**OHIO RIVER BRIDGES  
SECTION 5 - EAST END BRIDGE  
VALUE ENGINEERING STUDY REPORT**

**Item Number 5-118.00**

**VALUE ENGINEERING STUDY  
for  
Kentucky Transportation Cabinet**

**Final Report**

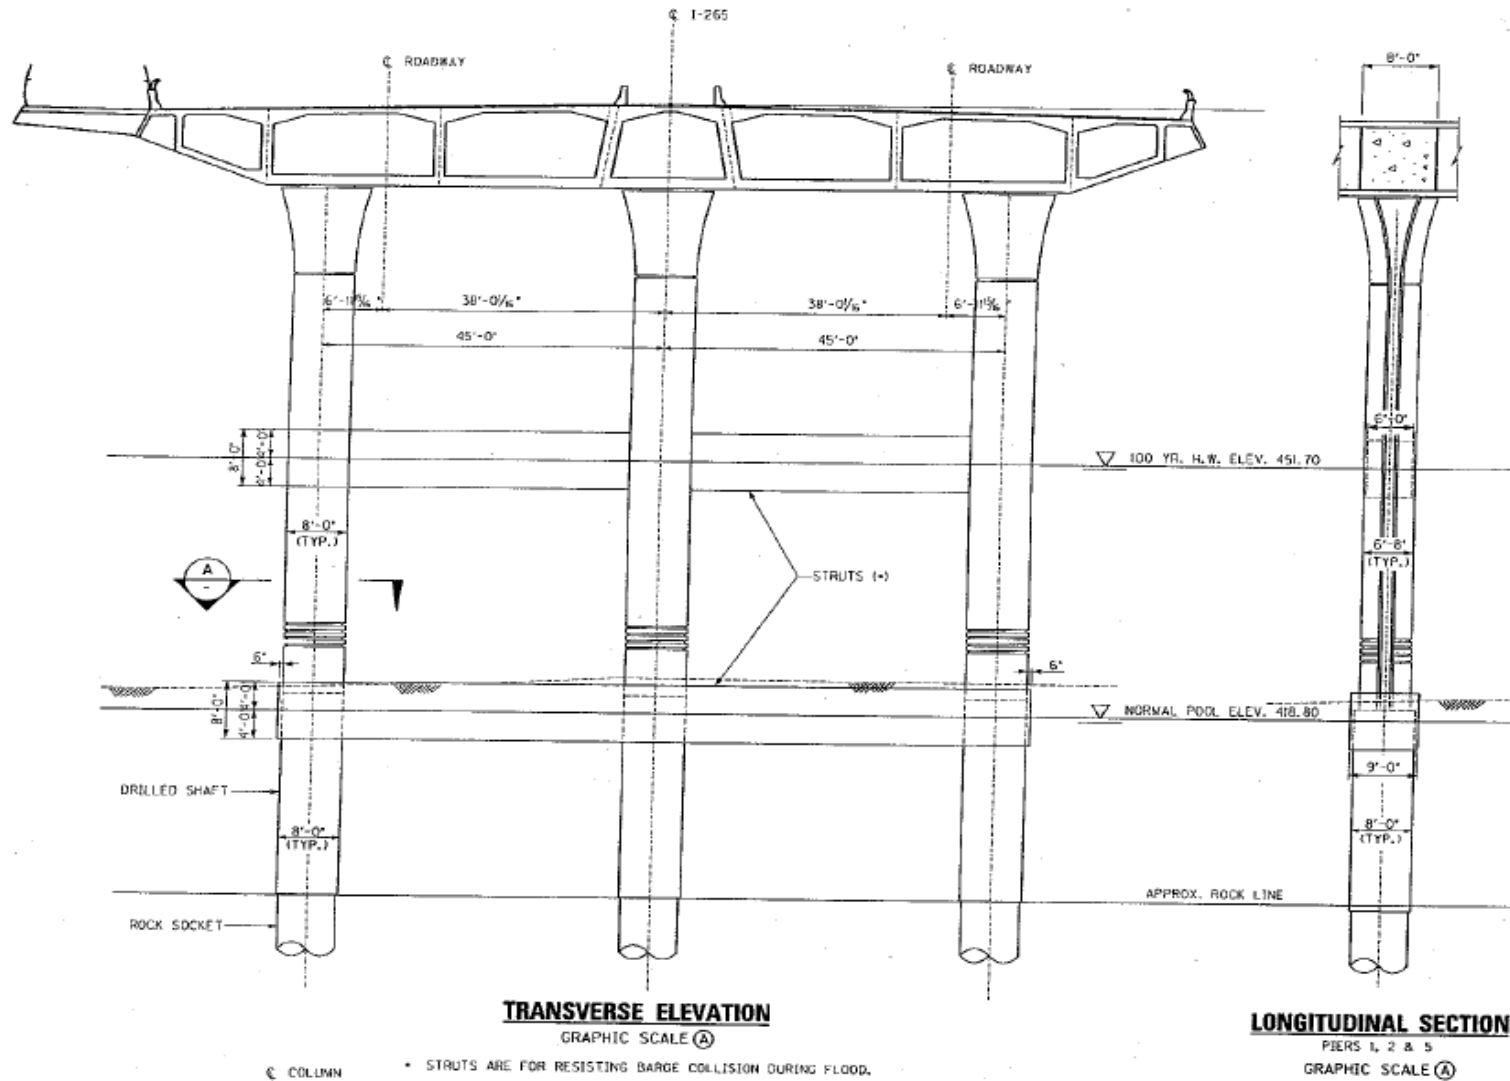
Columns for Pier 1 and anchor piers need to be able to resist barge impact forces between struts.

The Preliminary Plans show two horizontal struts between the three columns for Piers 1, 2 and 3. One strut is provided at normal pool level and the other strut is provided at the 100 year high water level. As noted on the drawing, these struts are provided to resist the barge collision forces.

SECTION AT TOP OF TOWER - ORIGINAL

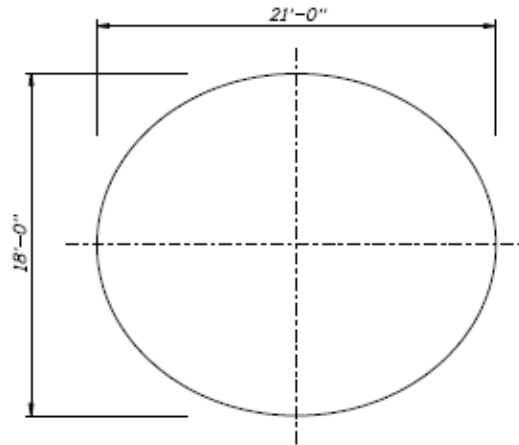
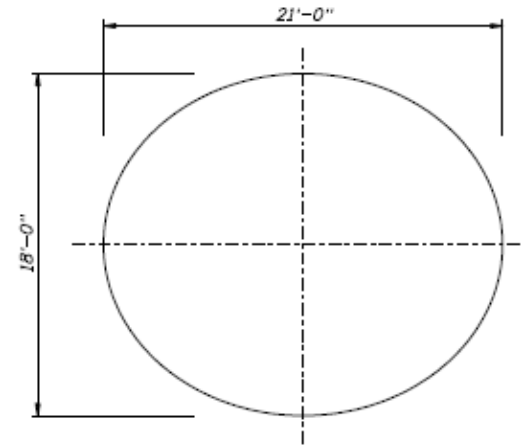
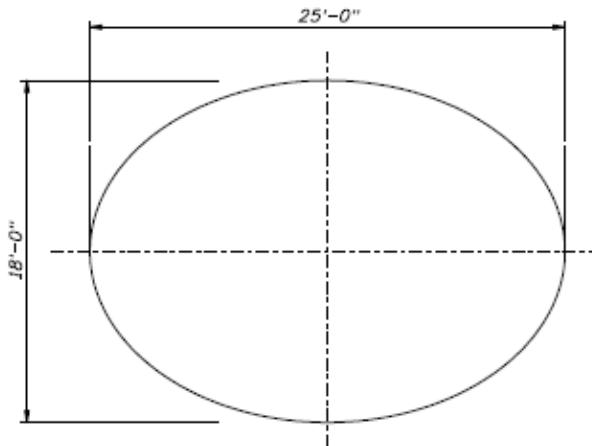
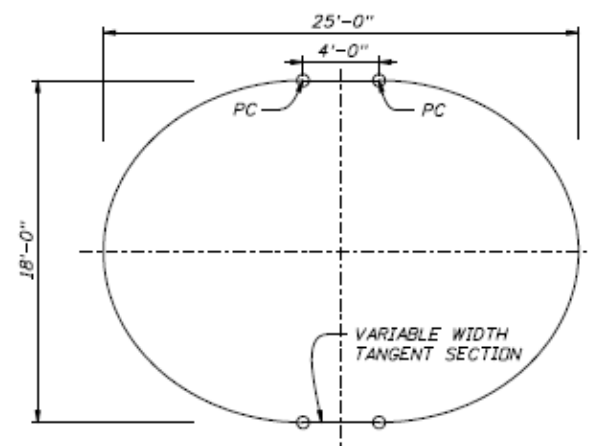
The Preliminary Plans show elliptical tower shapes that are a constant 18'-0" wide, but vary in length from 21'-0" at the top to 25'-0" at deck level. This variable length ellipse means the section must warp as it goes upwards and that each section of form work needs to be customized.

It is recommended to place a short variable width tangent section in the side walls to simplify the form system while having almost no visual change from the original proposal. The variable width tangent section allows the end forms and reinforcement details to remain constant for the full height of the tower which will speed construction and reduce costs.

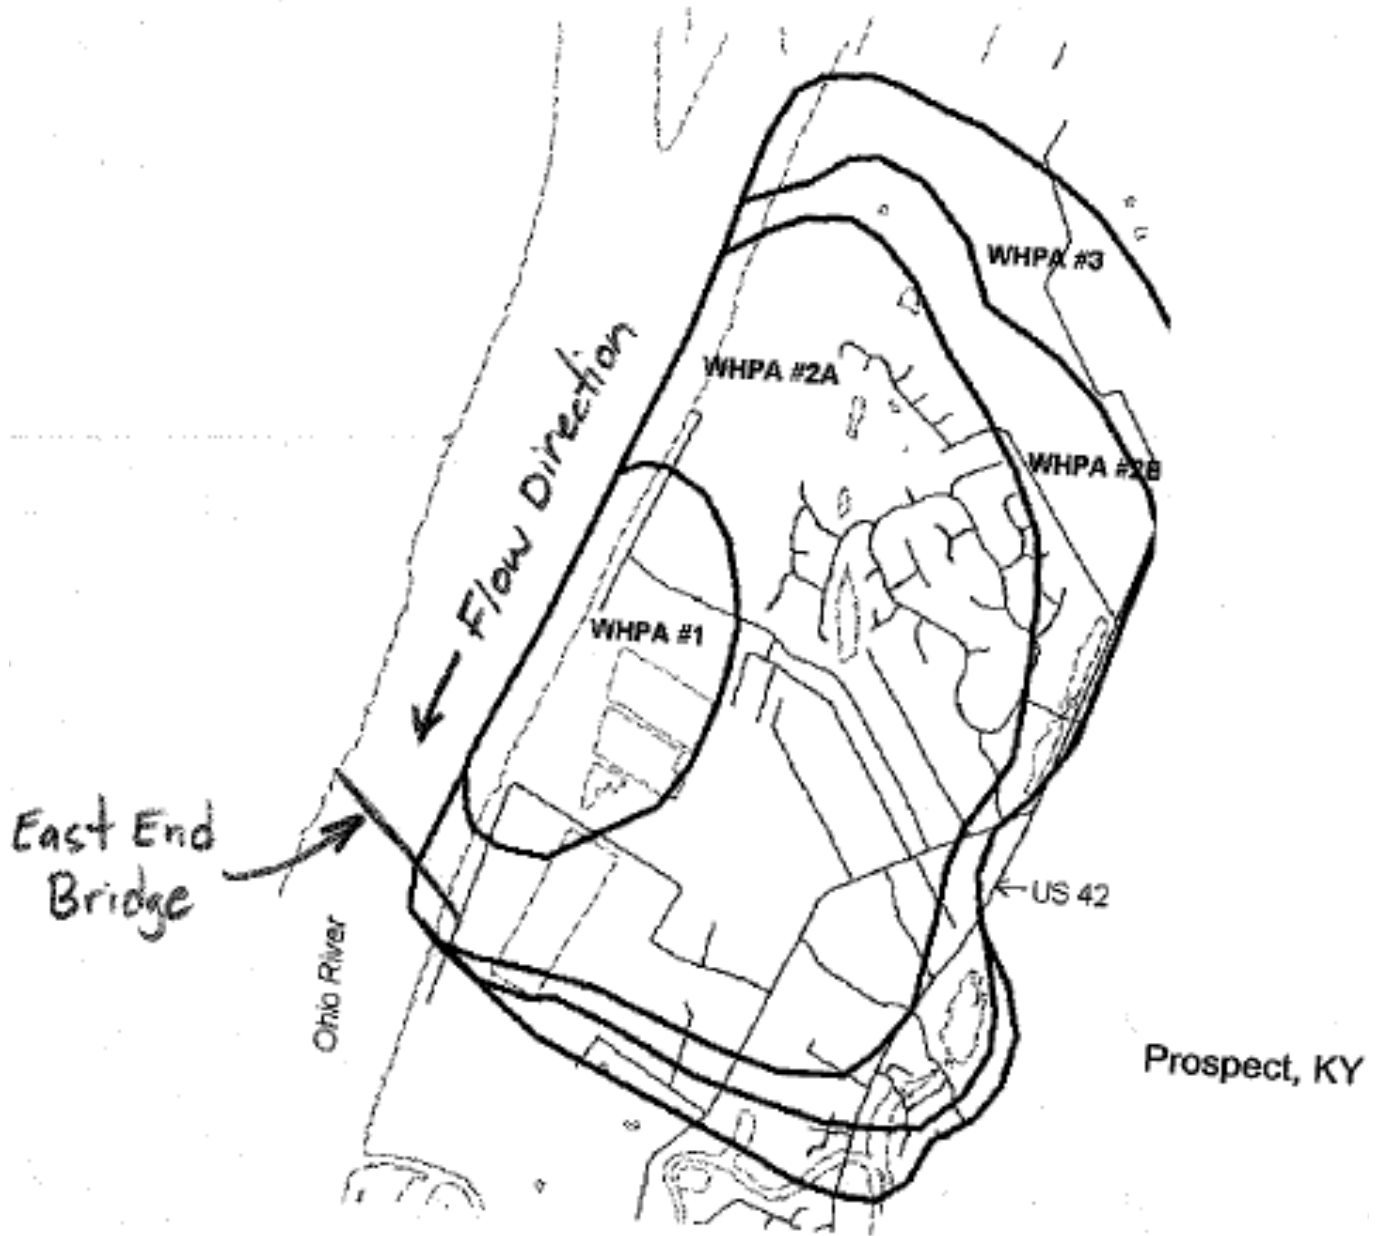
Eliminate the closed drainage system from the East End Bridge.

The drainage deck analysis performed by the Design team indicated that the FEIS required the bridge deck runoff be captured in a closed drainage system and piped to a treatment facility located in Section 4. The intent of the treatment is to protect the Wellhead Protection Area (WPA) owed by the Louisville Water Company. This commitment in the FEIS for the Section 5 bridge project seems extreme and would require treatment of large volumes of deck runoff when the Louisville Water Company is only concerned with a toxic spill, such as a gasoline tanker leak. The VE team thinks it would be prudent to investigate eliminating this closed system from the bridge project and drain the deck directly into the Ohio River as is standard practice. This would reduce long term maintenance on the bridge, long term treatment costs, and reduce the size of the treatment chambers. Justification should be centered around the fact that the new bridge is on the downstream fringe of the WPA (see drawing) and with the flow of the river it is reasonable to assume that a spill will not likely infiltrate the WPA. Additionally, collection of the more routine pollutants from the deck such as oil, gas or salt would be much more concentrated and drained directly back into the WPA which is the area you are trying to protect. This change could result in a substantial cost savings due to reducing the need to treat large volumes of water.

SKETCH OF ORIGINAL DESIGN

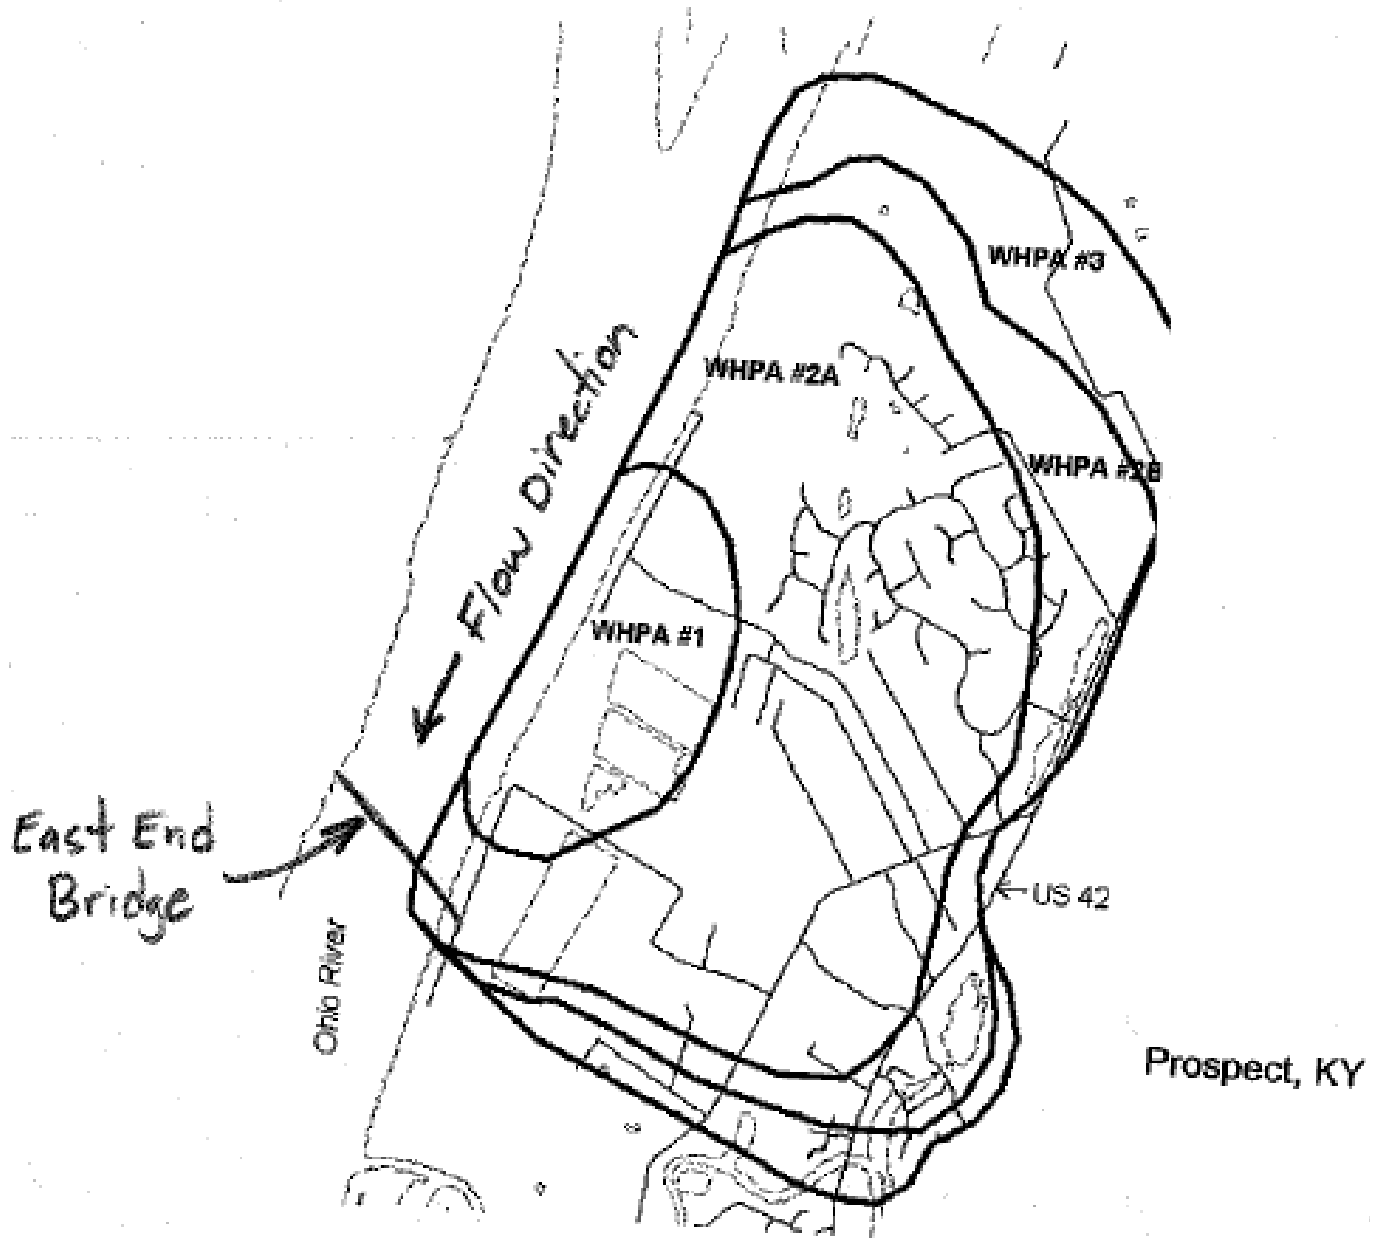
As illustrated on the attached drawing, the new East End Bridge is on the downstream fringe of the WPA. The VE team suggests that in lieu of capturing all the bridge deck runoff and piping it to the Section 4 project, it would be prudent to only capture the runoff that is directly inside the WPA to reduce the amount of runoff that will need to be treated and reduce the long term maintenance of the bridge drainage system. Given the location of the proposed bridge and the direction of flow, it seems unlikely that a spill outside the WPA will reach the sensitive area. Additionally, collection of the more routine pollutants from the deck such as oil, gas or salt would be much more concentrated and drained directly back into the WPA which is the area you are trying to protect. This change could result in a substantial cost savings due to reducing the need to treat large volumes of water.

**TYPICAL SECTION - A** Total width reduction of superstructure  
 GRAPHIC SCALE 1/8" = 1'-0"

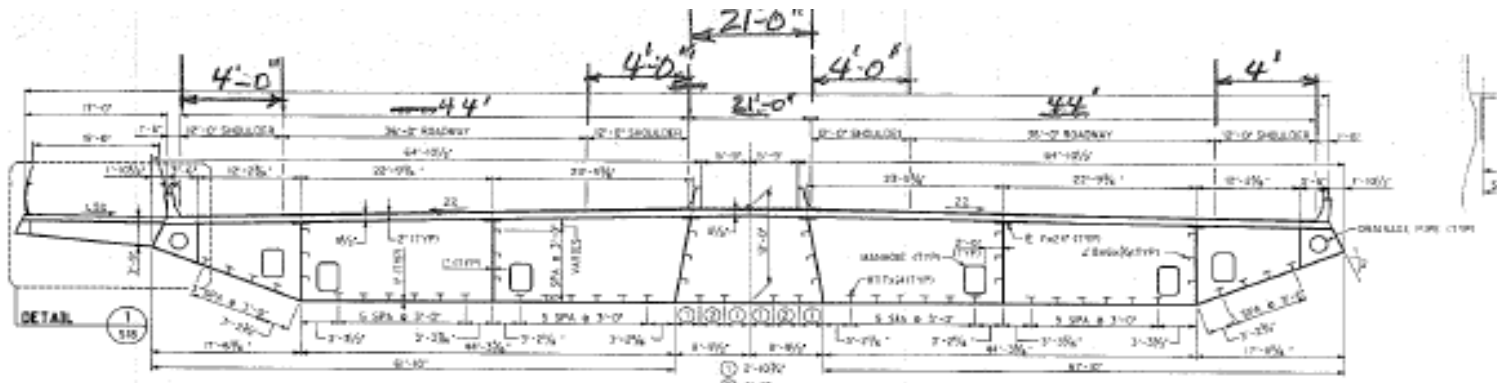
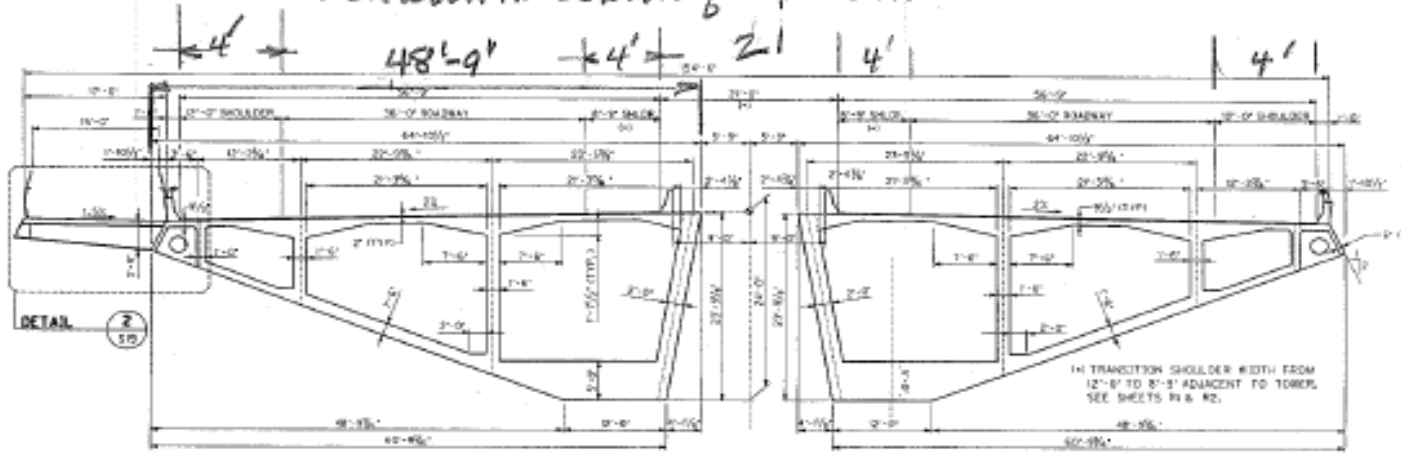
$(12-4) + (8.75-4) = 12.75' \times 2 = 25.5'$   
 reduction in width of superstructure.

$(12+12+12+12) - (4+4+4+4) + 6.5' = 25.5'$

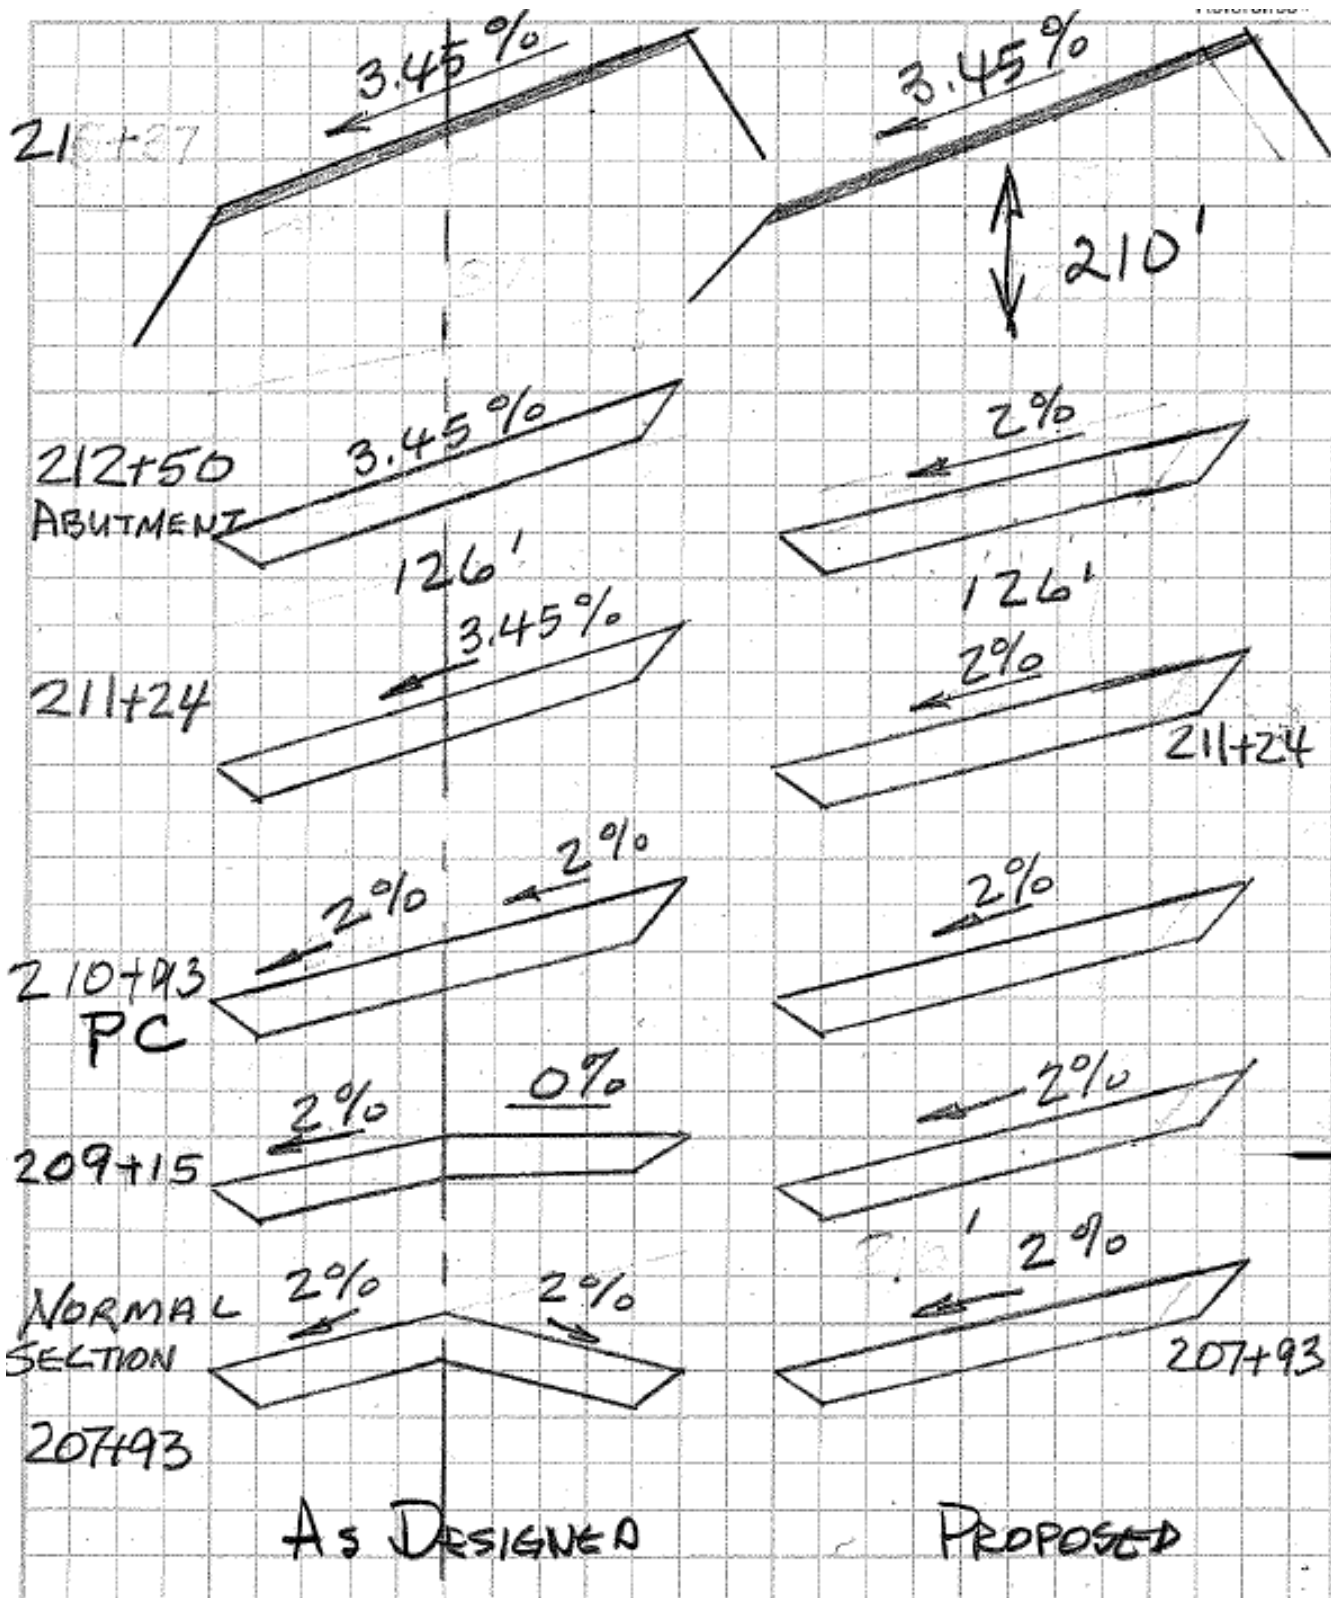
It is proposed that the cross slope in the northbound lanes be sloped toward the median for the entire length of the bridge. This will eliminate the portion of the transition from station 207+93 to 210+93.

This proposal is to revise the transition of the normal cross slope to the superelevation completely beyond the bridge. By sloping the northbound lanes toward the median, the only transition required would be that needed to transition from 0.02% to 0.0345%, which in the current design is accomplished in 210 feet.

If the 0.02% normal cross slope were to be continued to the end of the bridge at station 212+50, and then transitioned from 0.02% to 0.0345% the transition would end at  $(212+50)+(210') = 214+60$ .
